Rezoning Transportation Analysis
Petition Number: Insert Zoning Petition #2020-195
General Location Identifier: Tax ID 21159315

| Revision Log: | Date | Description |
| | 01-21-21 | First Review (LJ) |

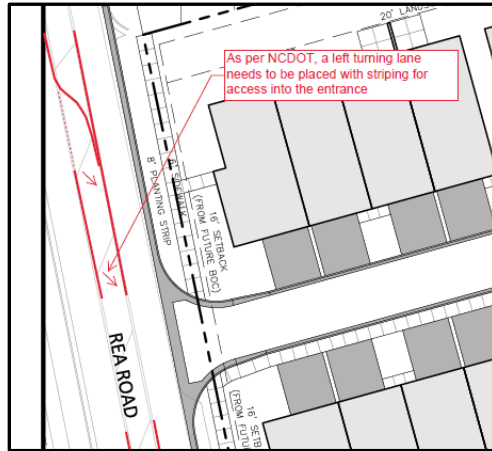
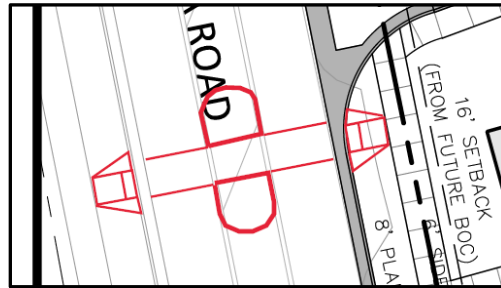
3. Revise site plan and conditional note(s) to commit to dedicate 35' right-of-way from the road centerline. The site plan shall label and dimension the right-of-way from the road centerline.
4. Revise site plan and conditional note(s) to commit to construct an 8-foot planting strip, and 6-foot sidewalk on Rea Road per Chapter 19 / Chapter 20. The site plan shall label and dimension both items from the back of curb and gutter and road centerline.
5. Provide a left turn lane on Rea Road as required by NCDOT. Restripe Rea Road, per NCDOT Roadway Standard Drawing for PAVEMENT MARKINGS Turn Lanes, 1205.05, to accommodate the left turning lane to include storage.

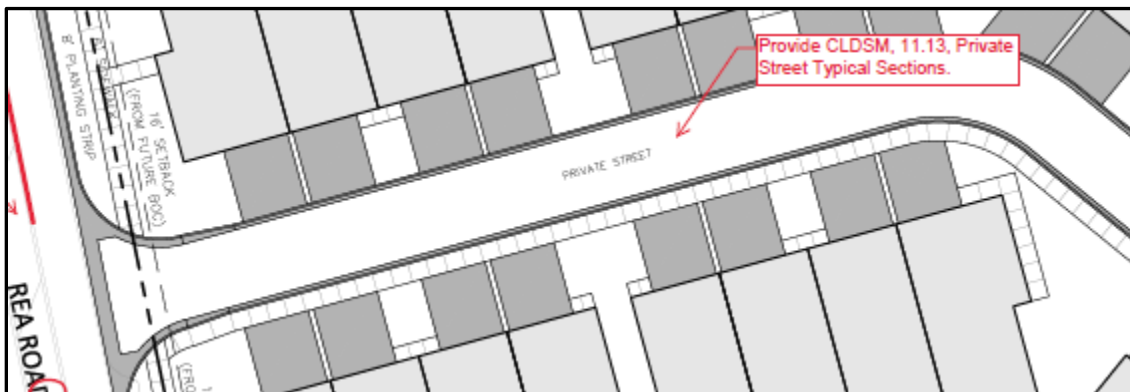
- 6. Site plan and conditional note(s) revisions are needed to meet CLDSM standards. Provide a pedestrian refuge across Rea Road, per CLDSM, 11.41, complying with ADA/PROWAG standards. The pedestrian refuge also meets the Charlotte WALKS Policy.
